CERTIFICATE OF REMEDIATION

Property: 907 Henderson Street, Lots 7 & 8, Block 8, Baker W R NSBB Subdivision. The property currently includes two historic structures. The southern structure (907 Henderson) is a historic one-story wood frame single family residence and the adjacent structure to the north (915 Henderson) is a two-story brick veneer storefront building. Together these two structures have 5,321 square feet of total living area and are situated on a 10,000 square foot (100' x 100') corner lot. This Certificate pertains to the single family residence at 907 Henderson.

Proposal: Alteration – Revision. This project was originally approved by the HAHC in June 2014. The applicant was originally approved to construct a 23'-1" x 17'-5" second-story addition atop the rear portion of a contributing house.

HAHC Action: Partially Approved: Approval of the addition renewal; Denial of the siding removal. Issuance of a Certificate of Remediation for the siding removal, to be replaced with wood lap siding to match original.

PHOTOS OF REMOVED SIDING

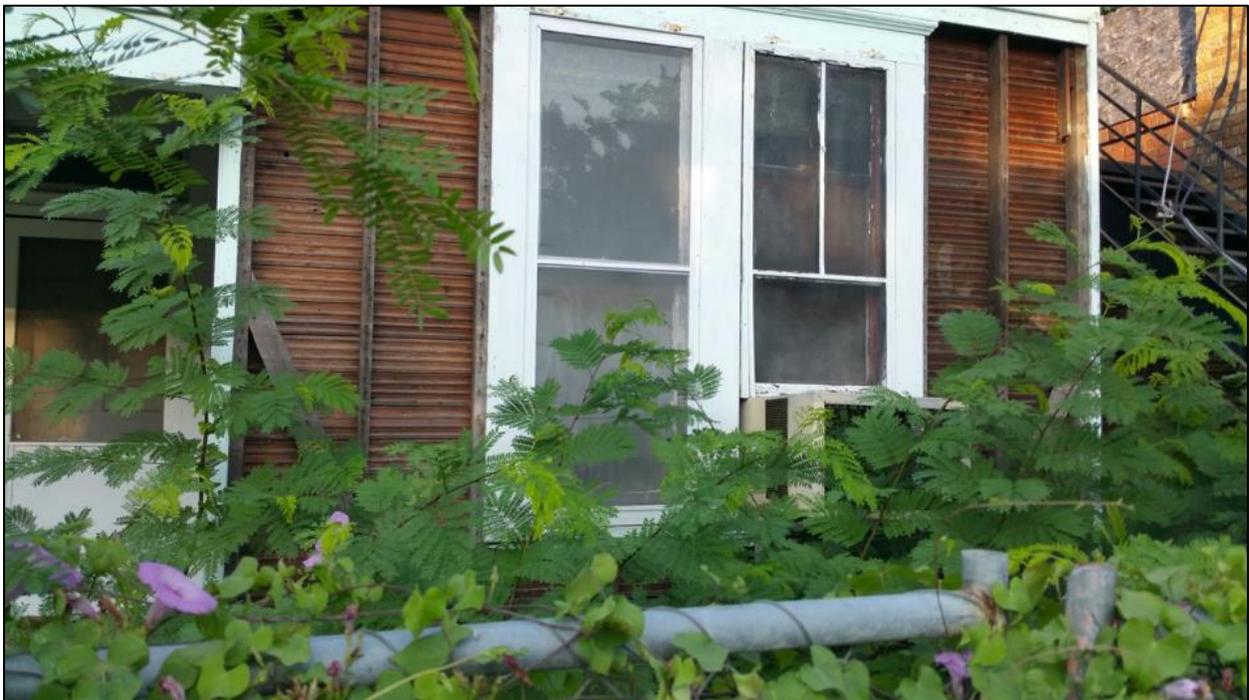
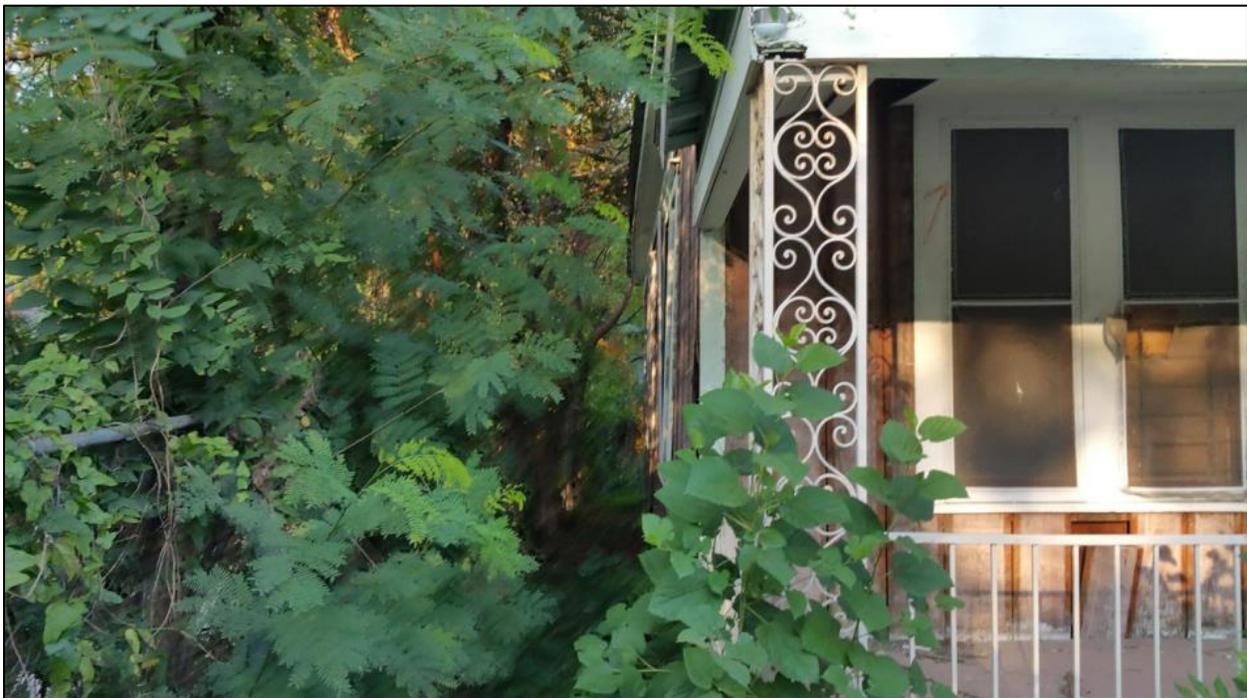
- The existing wood lap siding was removed from the structure without a Certificate of Appropriateness or HAHC Approval.
- The applicant states that the siding was removed because the builder was told that they had a permit, only to find out they did not

- The applicant claims that the siding was in very bad shape
 - Since the siding was removed and disposed of without HAHC approval or staff knowledge, staff was not able to evaluate the condition of the siding

<i>Removal of the original wood siding destroys significant historical and architectural material. The siding should be retained unless they are damaged beyond reasonable repair. Since the siding was removed, the structure was left open, causing further potential damage to the structure. Staff was not able to evaluate the condition of the siding prior to its removal and therefore cannot make an accurate evaluation of its condition.</i> |

Removal of original wood siding prior to staff inspection to determine if the cladding is damaged beyond repair does not comply with the Old Sixth Ward Design Guidelines. Original wood siding is a character defining feature and should be retained with damaged portions repaired with in-kind material.

- The applicant now proposes to replace the removed siding with wood lap siding to match original
